## Introduction

# TV

## MANUFACTURERS' RECEIVER TROUBLE CURES

Fig. 2 — Admiral

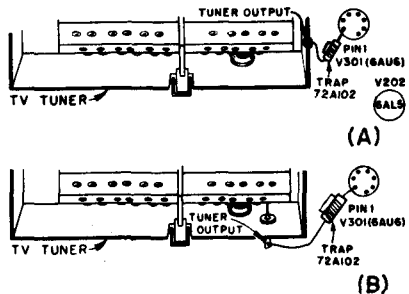
The picture may have a herringbone interference pattern produced

by the adjacent lower channel sound carrier. Close examination will often reveal the fine lines of herringbone pattern varying in accordance with the speech or music on the adjacent lower channel. Since f-m interference from other sources also produces a herringbone pattern, the presence of a station on the adjacent lower channel should be definitely determined.

For chassis 20Z1, a trap, part No. 72A102, is available for removing such interference. This trap is fixed-tuned and consists of a coil and fixed capacitor resonant at 27.25 mc. The trap is connected by removing the lead between the r-f tuner and the grid (pin 1) of the first video amplifier V301 (6AU6) and connecting the trap in place of the lead. See part (A) of the figure for location. This trap may be installed in the field without realignment. Later production runs of the 20Z1 chassis will have the trap incorporated in production.

For chassis 21B1 and 21C1, a similar arrangement is used. See part (B) of the figure for location.

Fig. 4 — Admiral

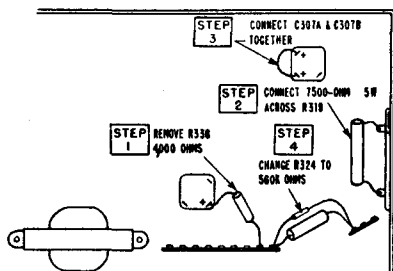
**Preventing picture cut-off**  
(see Fig. 4).

Blocking may occur if the tv set is tuned to a very strong tv signal which could drive the video amplifier to cut-off. With the video amplifier at cut-off, B+ voltage applied to the cathode of the picture tube will increase, thereby making the grid voltage more negative with respect to cathode, and driving the picture tube to cut-off. Also, since the gated agc tube is dependent upon voltage from the video amplifier for its operation, blocking of the video amplifier will prevent agc voltage from developing and the system will remain blocked.

1. Remove resistor *R336* (4,000 ohms).
2. Connect a 7,500-ohm, 5-watt resistor *R338* (part No. 61A1-18) across *R319*.
3. Connect together the positive terminals of filter capacitors *C307A* and *C307B*.
4. Change resistor *R324* from 180,000 ohms to 560,000 ohms, 1/2 watt (part No. 60B8-564).

Fig. 5 — Admiral

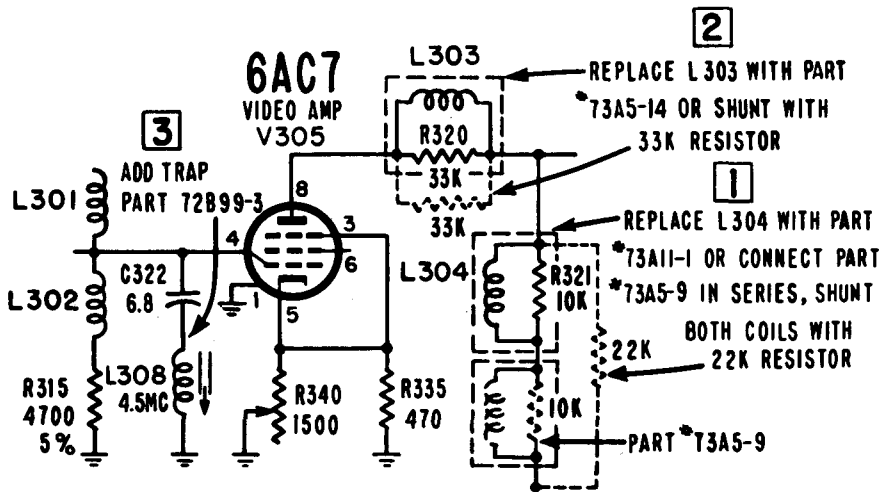
Picture smear or poor picture definition may be caused by improper receiver tuning to avoid receiving 4.5-mc beat interference. The natural tendency is to tune the set to eliminate the 4.5-mc interference in the picture, but this results in incorrect setting of the fine-tuning control for best picture.

To reduce or eliminate 4.5-mc interference in the picture, the following is recommended. Note: Some later production sets may have this change incorporated.

1. Remove peaking coil *L304* (part No. 73A5-9) and replace it with peaking coil, part No. 73A11-1. Peaking coil 73A11-1 has a three pi winding. If part No. 73A11-1 is not available, use two 73A5-9 peaking coils connected in series, with short leads, so that the coils are not more than  $\frac{3}{4}$  inch apart. Connect a 22,000-ohm,  $\frac{1}{2}$ -watt resistor (part No. 60B8-223) across this two-coil assembly.

2. Remove peaking coil *L303* (part No. 73A5-13) and replace it with peaking coil, part No. 73A5-14. Peaking coil 73A5-14 is coded with a blue dot. If part No. 73A5-14 is not available, part No. 73A5-13 should be left in the receiver and a 33,000-ohm,  $\frac{1}{2}$ -watt resistor (part No. 60B8-333) should be wired across it.

Fig. 6 — Admiral

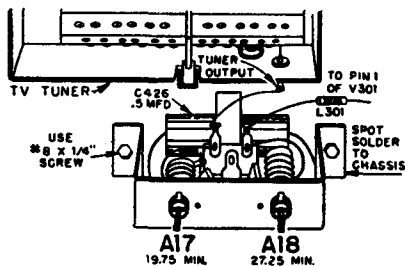
**ADMIRAL**Chassis 24D1  
through 24H1**Eliminating adjacent-channel  
interference (see Fig. 6).**

Two adjacent-channel traps *L309* (27.25 mc) and *L310* (19.75 mc) may be added between the output of the tv tuner and the input of the first video i-f amplifier *V301* (6AU6). This is done to eliminate the possibility of interference from the video carrier of the adjacent channel above, and the sound carrier of the adjacent channel below, the desired channel.

The 19.75-mc trap will remove adjacent-channel video interference, and the 27.25-mc trap will remove adjacent-channel sound interference.

Fig. 7 — Air King

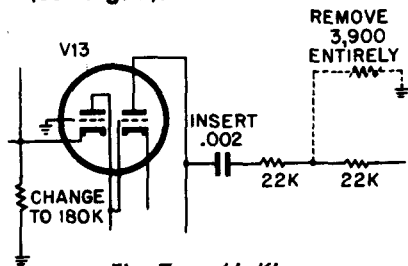
**AIR KING** 700-series Chassis  
**Increasing vertical sync stability**  
(see Fig. 7).

To increase vertical sync stability a .002- $\mu$ f capacitor should be inserted between the 22,000-ohm resistor and plate (pin 1) of the sync amplifier and phase splitting tube (V-13) as shown in the drawing. In conjunction with this change the 3,900-ohm resistor from the junction of the 22,000-ohm resistor to ground should be removed.

To further improve vertical sync stability in strong signal areas, change the 270,000-ohm cathode resistor of V-13 to 180,000 ohms. These changes are now being incorporated in later production runs.

Fig. 8 — Andrea

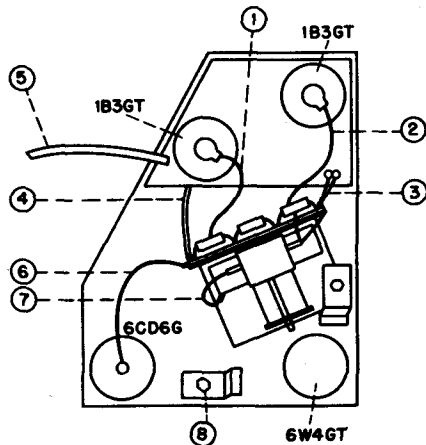
**ANDREA** Chassis VL-16  
**Preventing arcing and burning**  
(see Fig. 8).

Whenever any work must be done in the high-voltage compartment or if a tube is replaced in this section, proper lead dress must be maintained. Extreme care must be used to prevent connecting wires to the tube caps from touching any portion of the metal compartment or other components. Failure to observe this precaution may cause arcing and burning.

Wires 1, 2, 5, 6, and 7 shown in the figure must be kept in the clear. They must not rest on other components or on the sides of the compartment. Whenever parts are replaced, make these wires short and direct but do not put a strain on the parts. Wires 3 and 4 must not be pulled too tightly. Be sure to round off soldering connections on any work done. Also, do not turn the width coil slug (part 8 in the figure) out too far, thereby lowering the impedance, as this may cause the coil to overheat or even burn.

Fig. 10 — Arvin

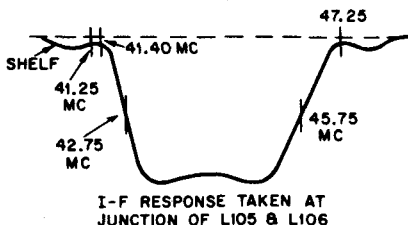
#### Intercarrier buzz reduction (see Fig. 10).

1. Check buzz due to intermodulation within the sync and audio tube, *V19*, by pulling out *V1*, 6AU6. Change *V19* if buzz is still audible.

Fig. 11 — Arvin

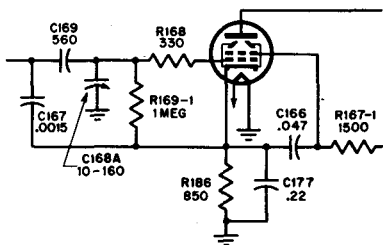
1. R186 850-ohm, 10-watt resistor added between cathode and ground of 6AV5GT tube.
2. Ground side of C166 capacitor rerouted to cathode of 6AV5GT.

3. *C177*, .22- $\mu$ f, 400-volt capacitor added to cathode circuit of 6AV5GT tube.

Fig. 13 — Belmont-Raytheon

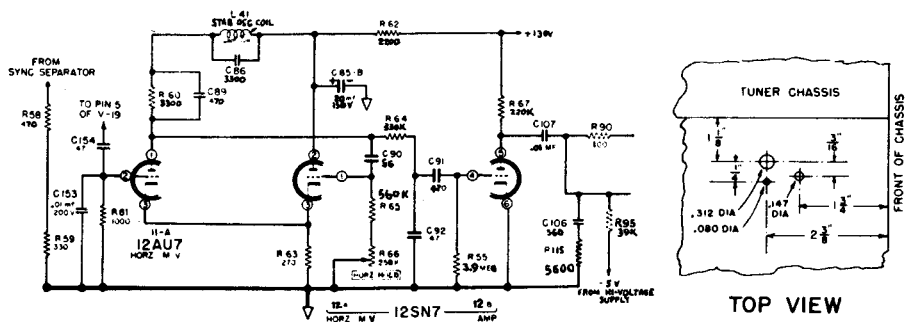
1. Change 1,800-ohm resistor on terminal board supplied with modification kit to 3,300 ohms.

2. Remove 470  $\mu\text{f}$  ( $C89$ ) (pin 2 of  $V11$ ) from chassis, and rewire across 3,300-ohm resistor on terminal board supplied with kit.
3. Remove 33,000-ohm resistor ( $R60$ ) connected from pin 1 of  $V11$  to pin 2 of  $V12$ .
4. Change  $R64$  (pin 1 of  $V11$ ) to 330,000 ohms.
5. Change  $C92$  (pin 6 of  $V12$ ) to 47  $\mu\text{f}$ .
6. Connect blue wire to pin 1 of  $V11$ .

Fig. 14 — Bendix

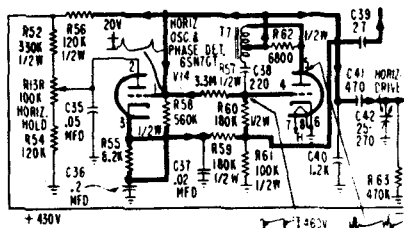
tate easier mechanical adjustment of the focus coil, a revision of the horizontal oscillator and phase-detector circuit may be made as shown in the figure.

1. Remove lead of capacitor C39 from the junction of capacitors C40 and C41.

Fig. 15 — Calbest

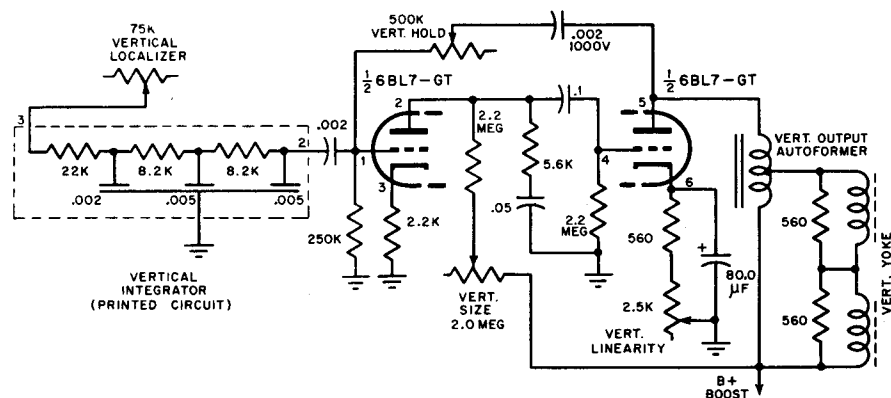
In the event foldover at the top of the picture is experienced with the 6BL7-GT, add a resistor whose value is from 22,000 to 47,000 ohms to the 250,000 resistor in the grid circuit.

Fig. 16 — Capehart-Farnsworth

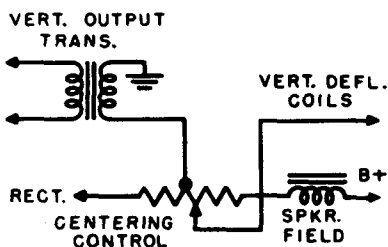
A vertical-centering control may be installed by performing the following operations. The control is a 10-ohm, 2-watt center-tapped potentiometer, part No. 450662A-1. It should be installed in some convenient location on the rear chassis apron.

1. Connect the control in series with the speaker field coil (filter choke), using the end terminals of the control.
2. Open the vertical output transformer yoke lead.
3. Connect the transformer lead to the fixed center tap on the control.
4. Connect the yoke lead to the variable arm on the control.

Fig. 20 — Capehart-Farnsworth

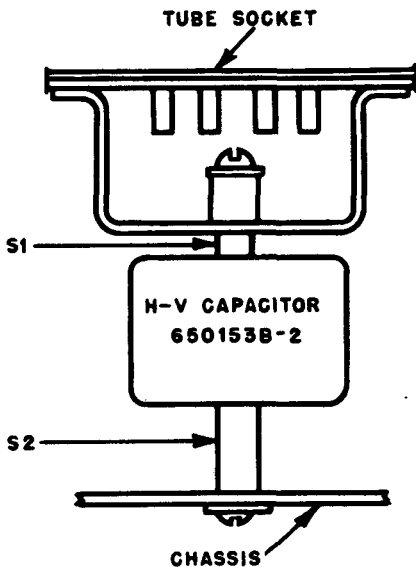
#### *Internal arcing in h-v capacitor (see Fig. 20).*

This is the 500- $\mu\mu\text{f}$ , 200,000-volt high-voltage filter capacitor, part No. 650153B-2.

Fig. 21 — Capehart-Farnsworth

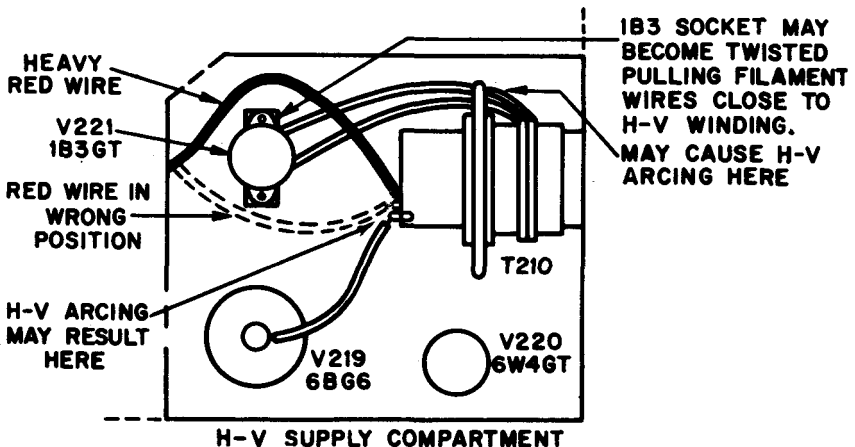
If necessary to replace the 1B3 rectifier tube in h-v section of the receiver, it is possible, if care is not exercised, to disarrange the wiring. This might cause high-voltage arcing or a short to develop resulting in a burned-out transformer. Note carefully in the sketch the proper position of the 1B3 socket, so as to avoid drawing the filament-supply leads against the transformer coil. Also note correct position of the heavy red wire between the horizontal-output transformer and the deflection yoke.

It must be between the 1B3 tube and power-supply shield — not between the 1B3 and 6BG6 tubes.

Fig. 23 — Capehart-Farnsworth

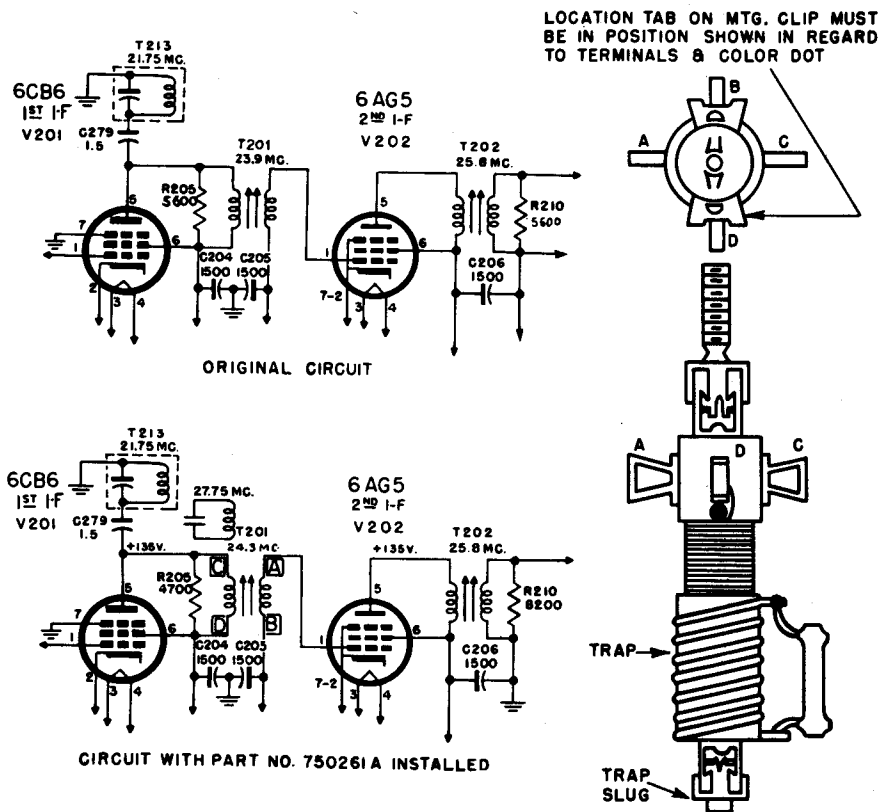
For the few areas where severe adjacent-channel interference is encountered, a special trap is available. This trap, part No. 750261A, is a combined first i-f transformer and

trap and replaces the original first i-f transformer.

Fig. 24 — Capehart-Farnsworth

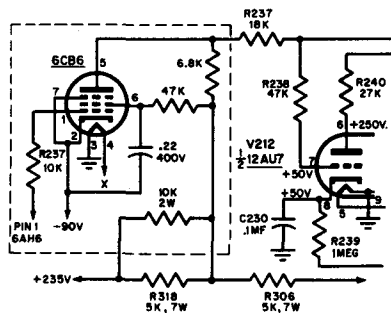
### Modification for improved fringe-area operation (see Fig. 24).

It is possible, under particularly severe conditions, that greater range of the contrast control may be required without loss of sync. If so, a

6CB6 sync-amplifier tube may be easily installed on the chassis between the 6AL5 (*V204*) and 12AU7 (*V212*). Using a socket punch, cut a 5/8-inch hole in the chassis. Install socket and wire as shown in the figure.

Fig. 25 — Capehart-Farnsworth

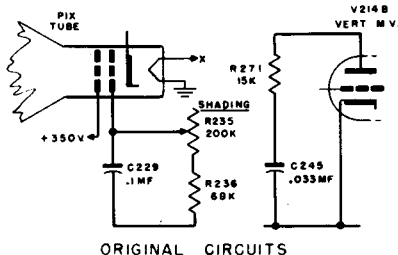
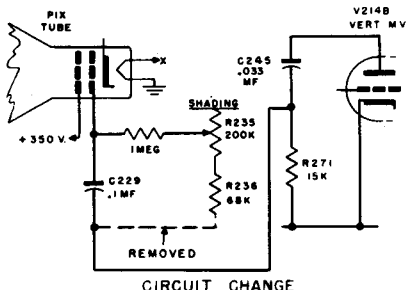
### Blanking of vertical-retrace lines (see Fig. 25).

Fig. 26 — Capehart-Farnsworth

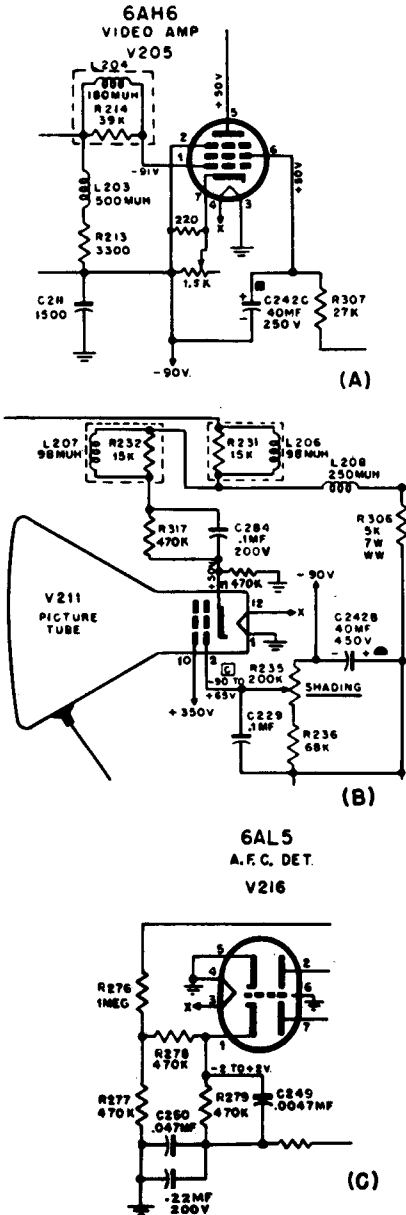
A condition of vertical linearity instability evidenced by a cyclic, or

repetitive, expansion and contraction in the vertical direction of a portion of the picture can be corrected by the following circuit change. Remove the center arm of the *Height Control* (R273) from +310 volts and connect to the junction of R266 and C243A. Remove R266 from +310 volts and connect to +295 volts. All connections are in a convenient position and it should take only a few seconds to change the two wires involved.

Fig. 27 — Capehart-Farnsworth

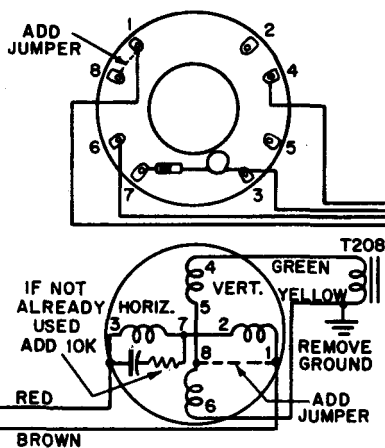
Some high-voltage breakdowns between yoke windings have been reported in yokes 750192A and B which are furnished with models 335 and 337 (with the above chassis). To reduce the potential difference between windings, the following change procedure should be followed:

1. Remove the chassis.

**Fig. 29 — Crosley**

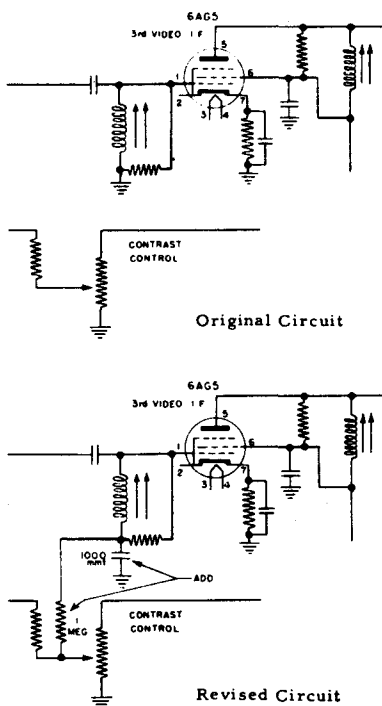
In some cases where these sets are operated in areas where the signals from one or more stations is exceptionally strong it may cause the contrast control to operate very critically. This condition can be corrected without losing sensitivity in the re-

ceiver by adding a variable bias to the third picture i-f stage. This can be accomplished by making the following wiring changes:

Fig. 30 — Crosley

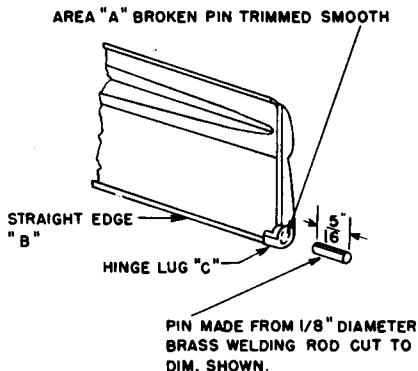
### Repair of broken hinge (see Fig. 30).

When a broken hinge pin is encountered on the doors, repairs can easily be made in the following manner:

Fig. 31 — Crosley

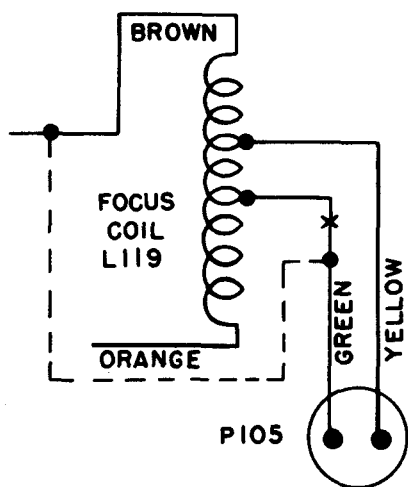
If it becomes necessary to increase the range of the *Focus Control* on the 20- or 21-inch models of 1952, connect the focus coil (*L119*) as shown in sketch and explained below.

1. Cut the green wire at X and tape the bare end of the portion of wire that remains on the focus coil. Be sure to allow enough wire to remain on the coil, just in case it is ever necessary to reconnect it in its original manner, if for any reason the picture tube must be replaced at a later date.

Fig. 32 — Crosley

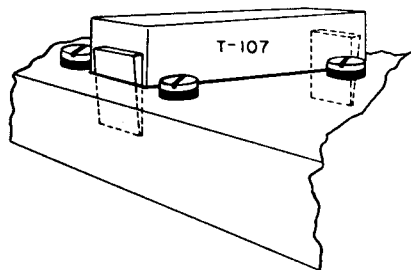
Horizontal-sweep sing can be caused by vibration of the mounting bracket on the horizontal-output transformer, *T107*. This mounting

bracket occasionally vibrates at a subharmonic of the 15,750-cps horizontal-sweep frequency. On later production sets this condition has been corrected by dipping the core and mounting bracket in a high melting point wax.

Fig. 40 — DuMont

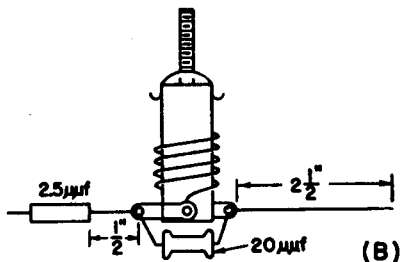
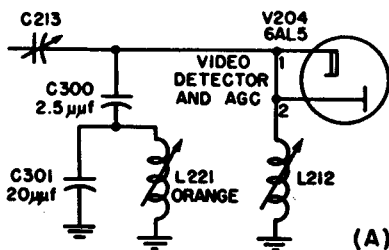
**Adjacent-channel interference (see Fig. 40).**

Fig. 41 — DuMont

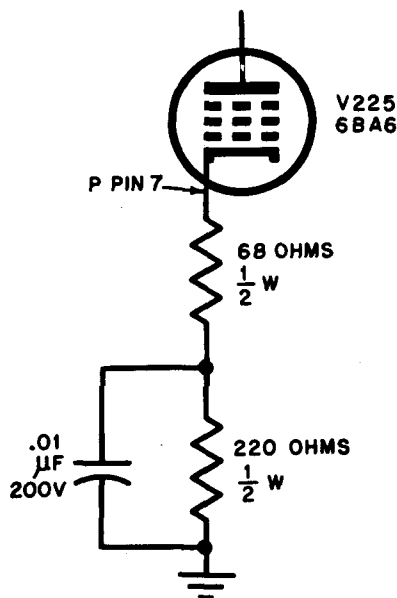
**Correcting vertical jitter**  
(see Fig. 41).

Fig. 45 — DuMont

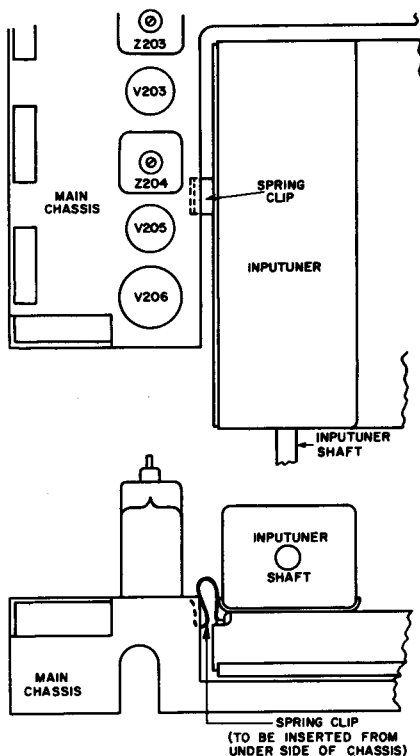
**DUMONT Model RA-109A**  
**Elimination of channel 7 beat**  
(see Fig. 45).

Fig. 47 — DuMont

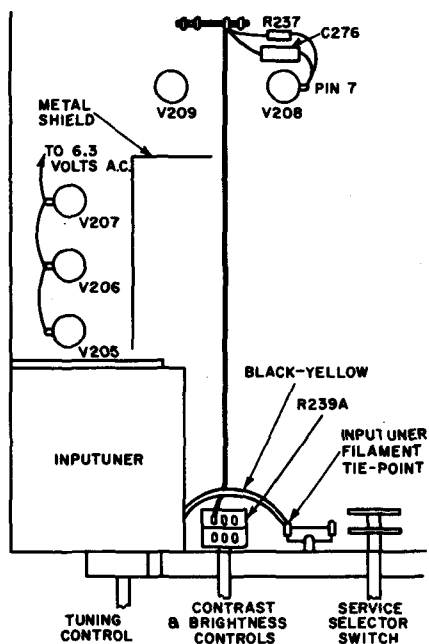
**Regeneration in video i.f.**  
(see Fig. 47).

Fig. 48 — DuMont

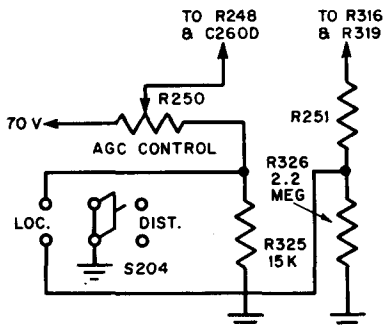
### Installation of Local-Distance switch (see Fig. 48).

Fig. 49 — DuMont

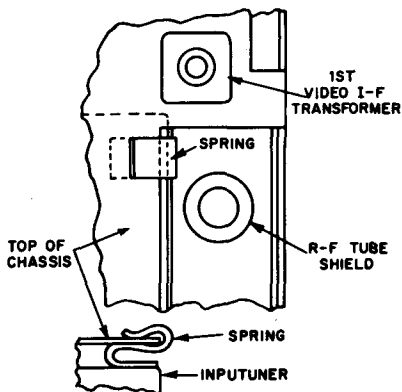
To reduce regeneration, a grounding spring (part No. 30015401) should be inserted between the *Inputuner* and the chassis as shown in the illustration.

Fig. 50 — DuMont

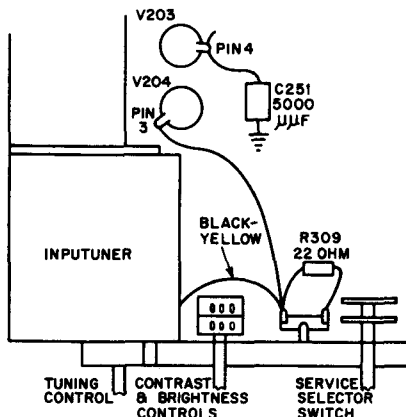
**DUMONT Model RA-111A**  
**Elimination of channel 7 beat**  
(see Fig. 50).
